EXAMPLE #1

For projects less than one acre and no new connections to the City/County storm sewers

UNIVERSITY OF MICHIGAN
WILLIAM L. CLEMENTS LIBRARY INFRASTRUCTURE IMPROVEMENTS AND ADDITION
UM PROJECT NUMBER: P00001692
RIGHT OF WAY GRADING PLAN

PRELIMINARY SITE PLAN REVIEW

SCALE HORIZ. 1"=20' VERT. 1"=2' | INCH 0 1
DRAWING NO. CG1.1
SHEET NO. ____ OF ____

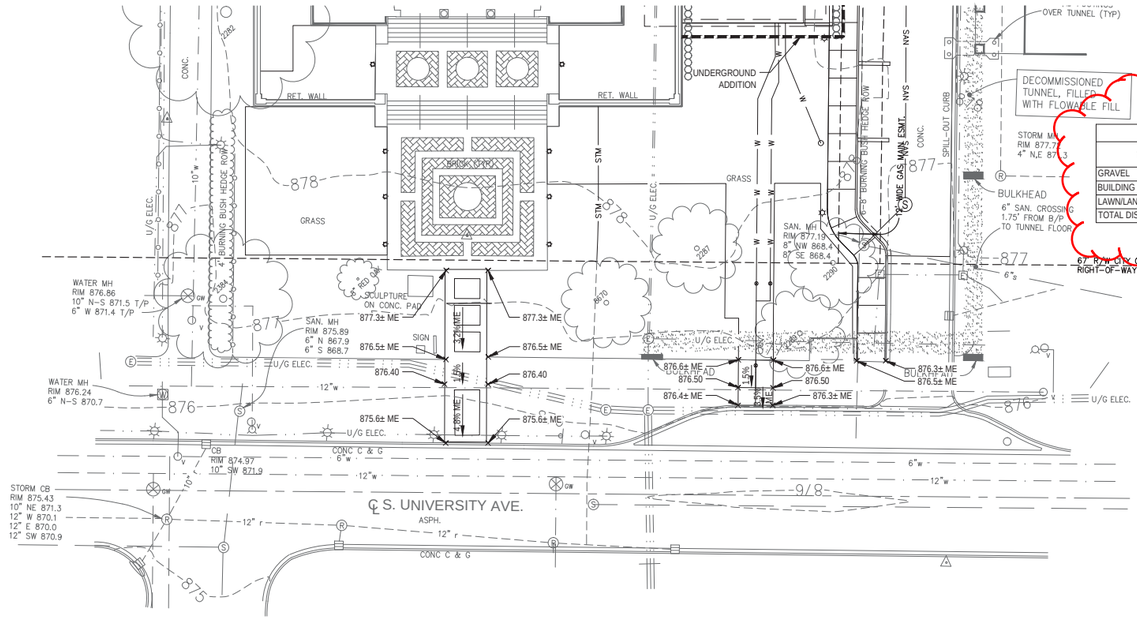
Show chart of with change in impervious -see attached example chart. Increase in impervious must be reviewed/approved by U-M Campus Planning and project team may be directed to design additional storm water management BMPs.

Provide a list of elective storm water BMP's to be installed and quantify benefits, if feasible.

Include the language: "Construction and operation of the storm water (infiltration/detention pond) or (BMP's on the plans) is/are in compliance with the requirements of State and Federal water pollution control laws."

Replace chart with format matching example chart below

sheet number: T-1C

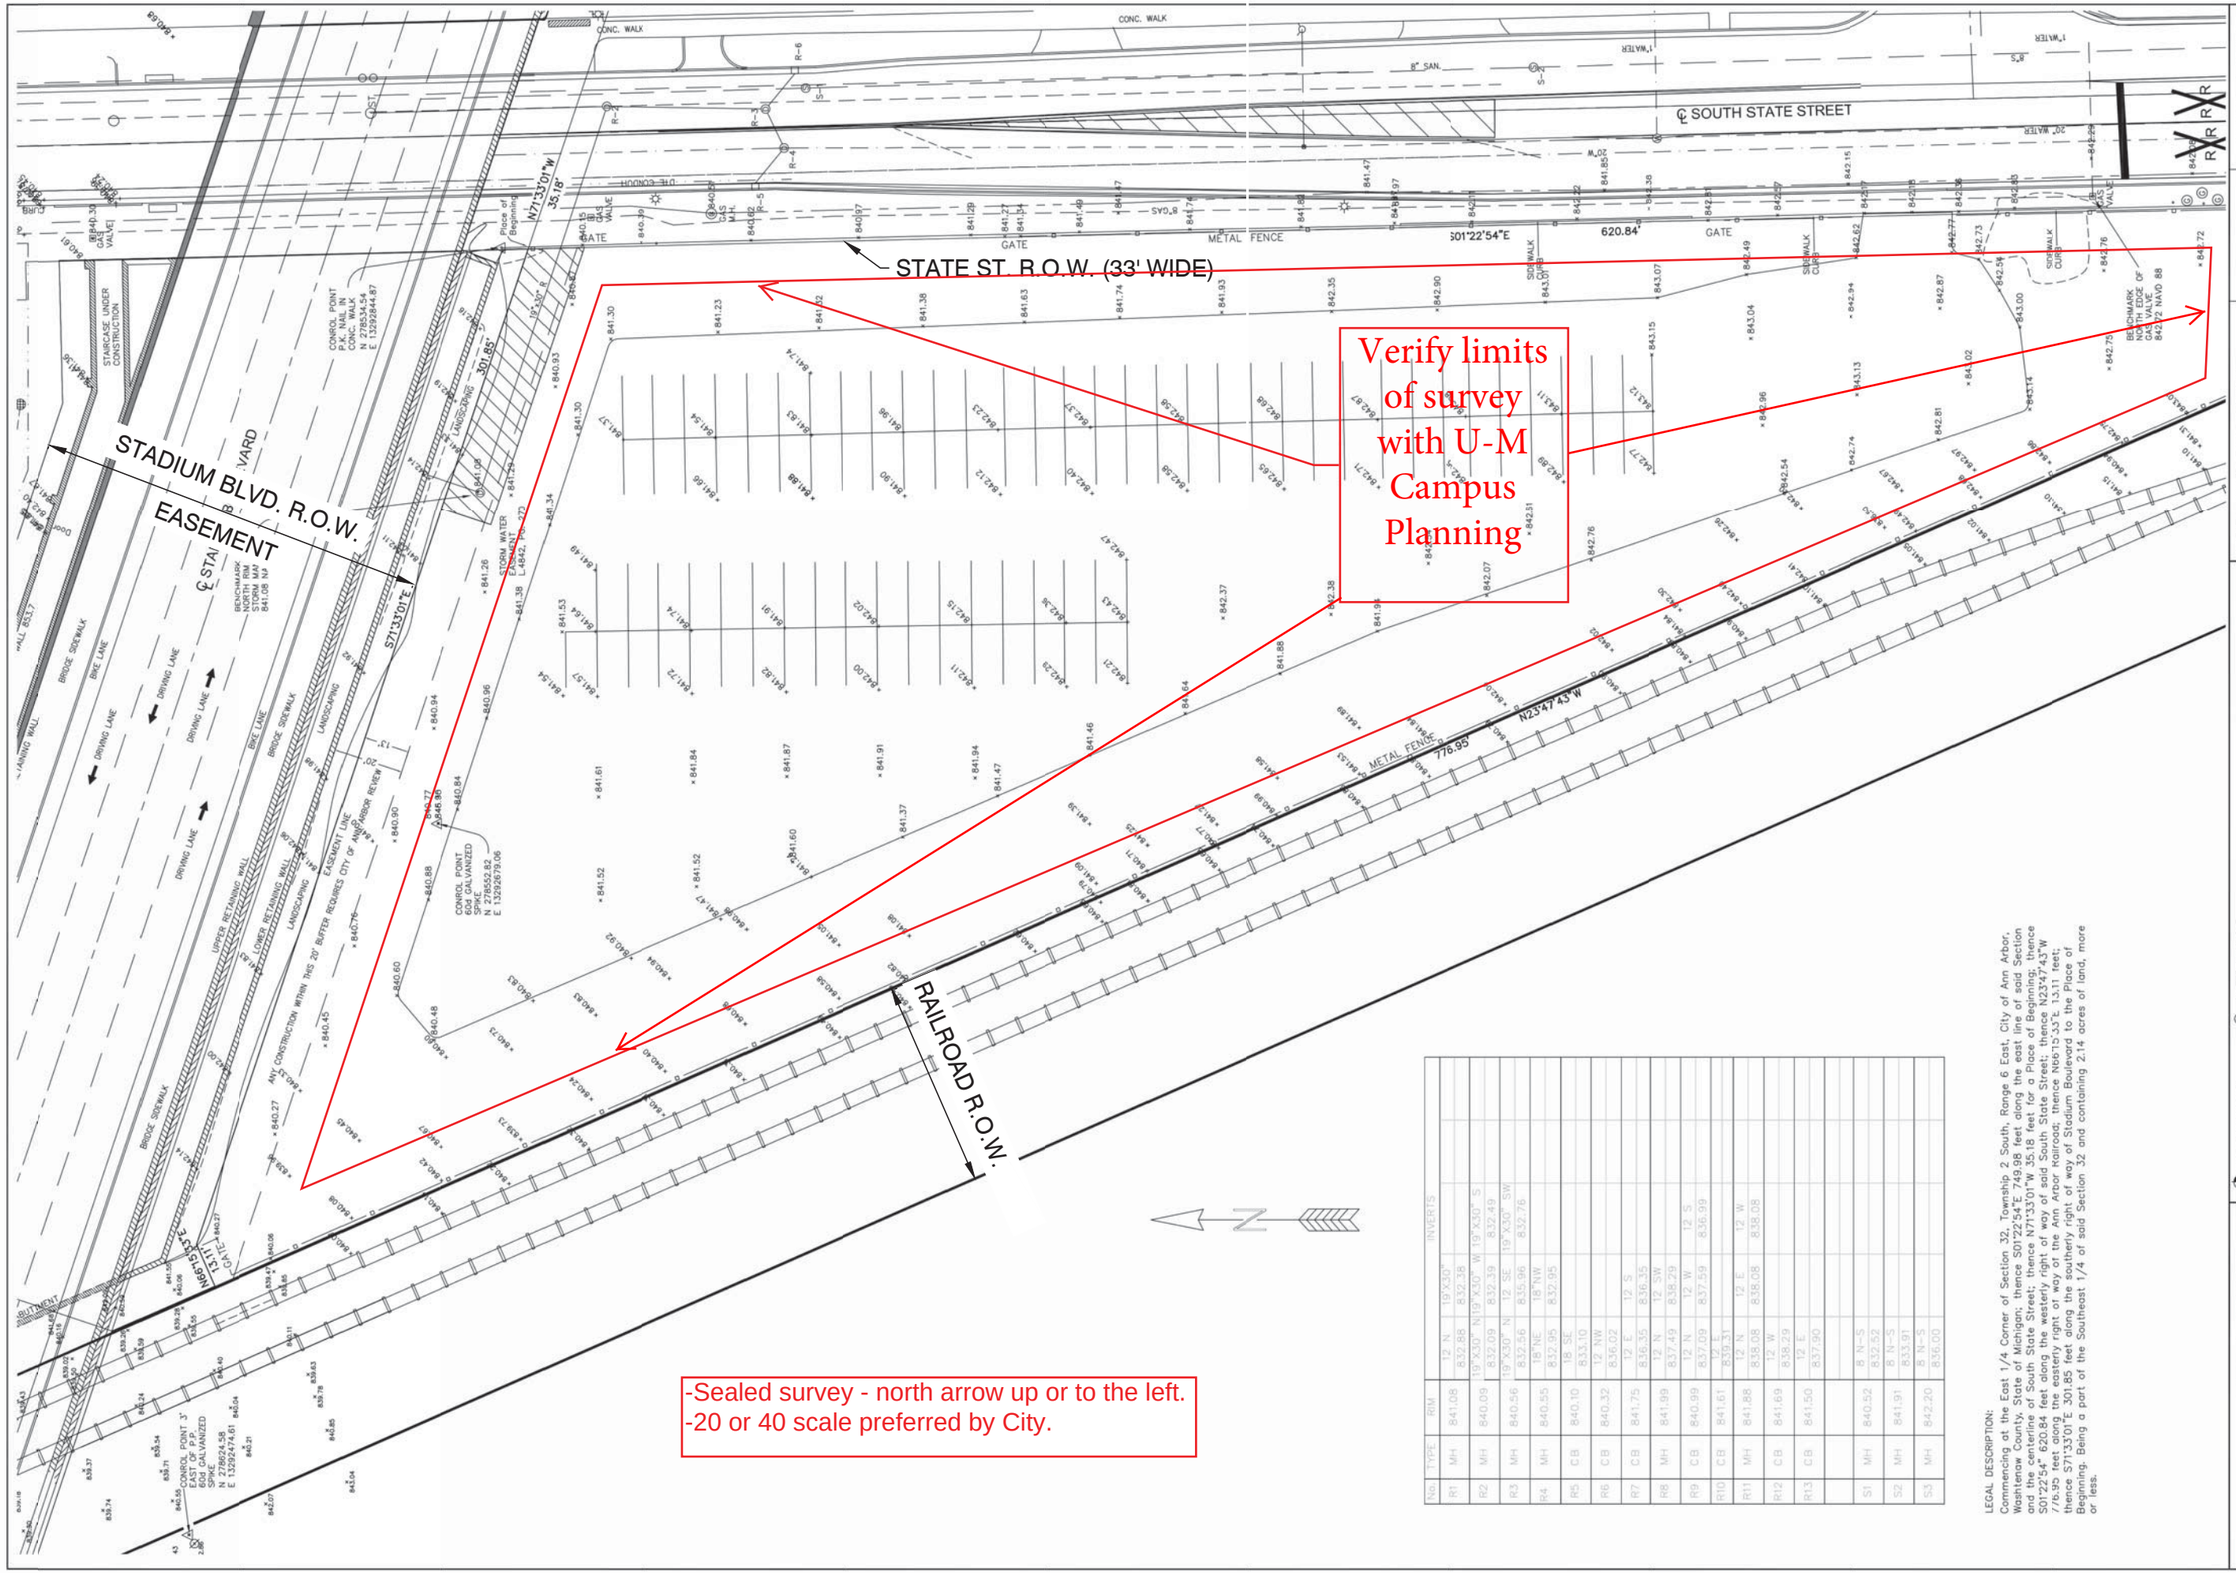
For City projects only - Title Sheet Listing type of City Review

C001C

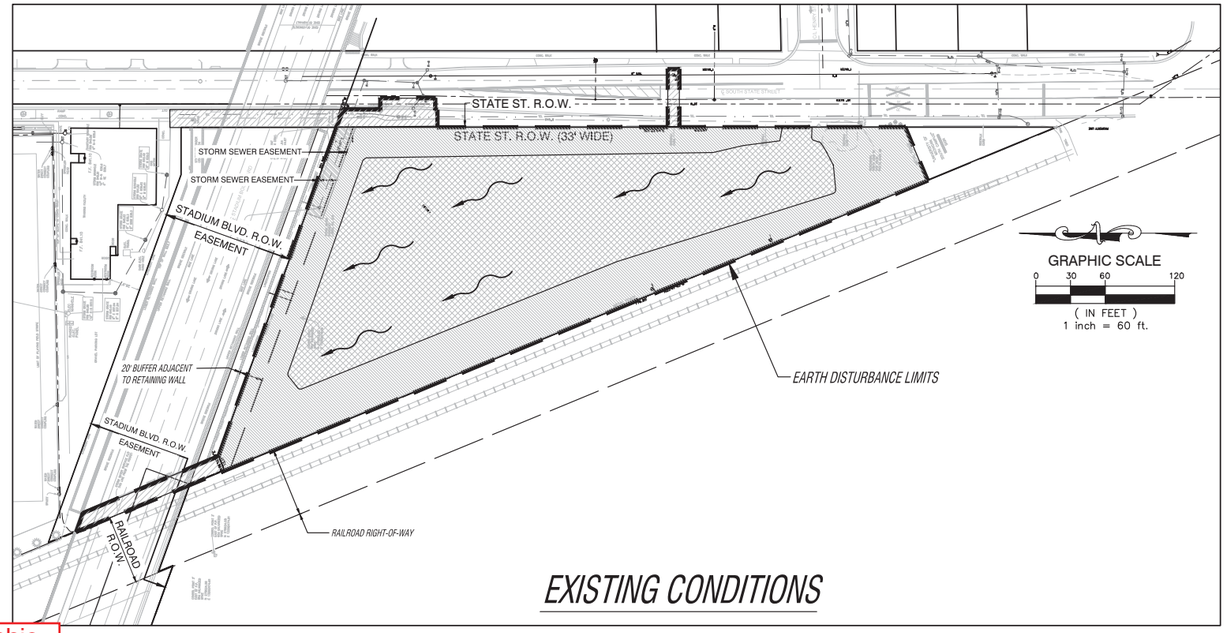
-Sealed survey - north arrow up or to the left.
-20 or 40 scale preferred by City.

PROPOSED CONDITIONS

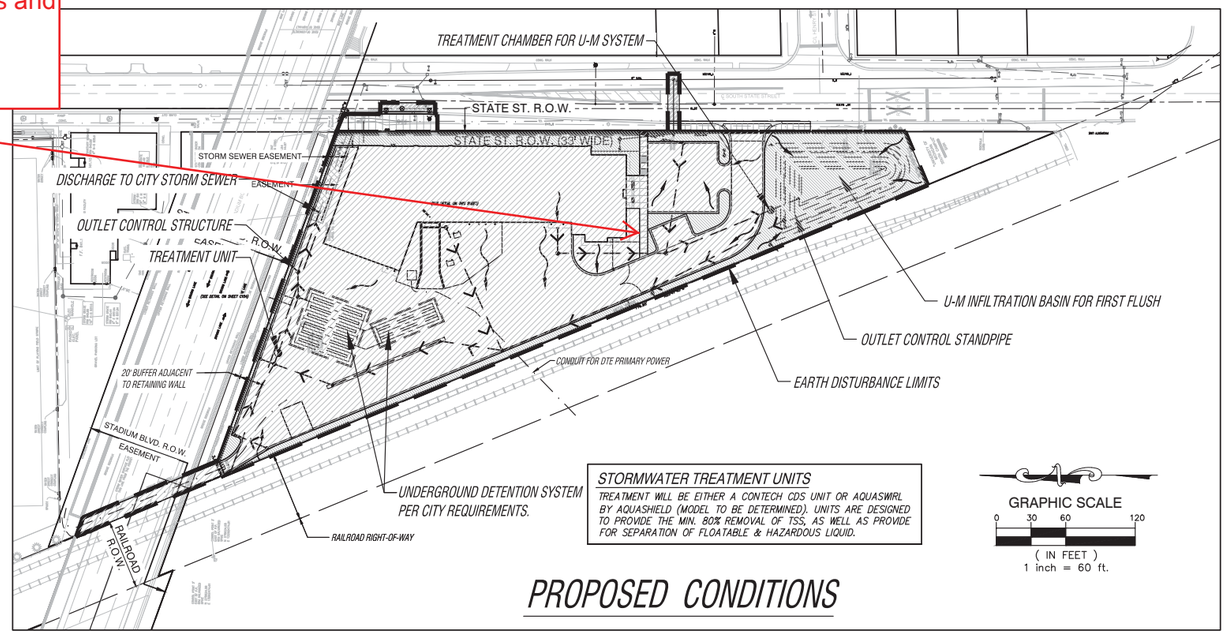
- Storm water sheet.
- Show drainage patterns of proposed and existing conditions with different hatching based on imperviousness. (See Campus Planning level of detail provided on U-M property)
-Provide narrative summarizing storm water as noted below.

Adjust this graphic to provide hatching of surface based on imperviousness and remove site paving details

project number: UM AEC : P00008399
sheet number: C104C

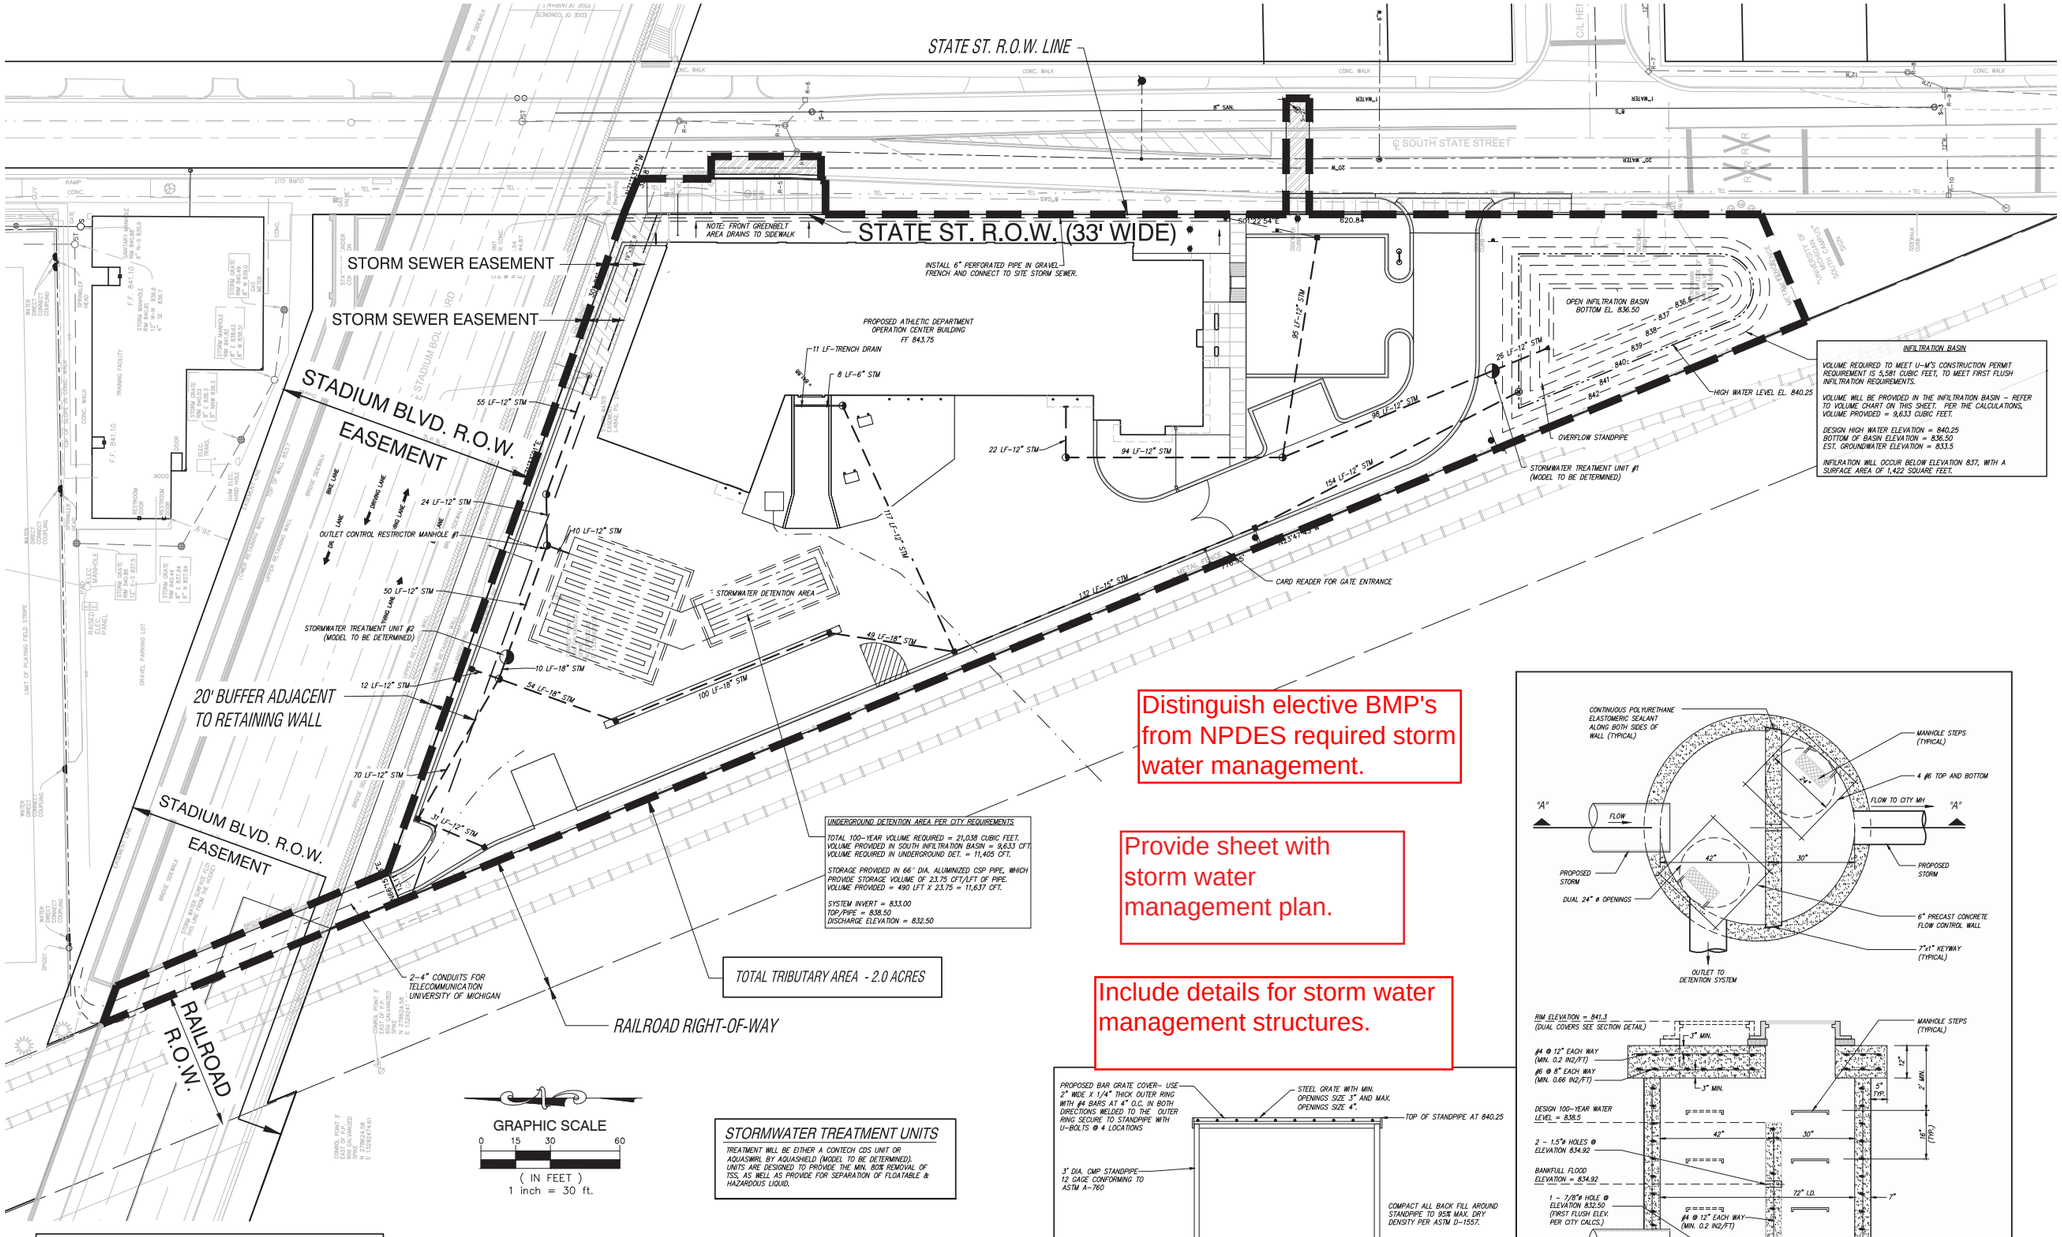
Distinguish elective BMP's from NPDES required storm water management.

Provide sheet with storm water management plan.

Include details for storm water management structures.
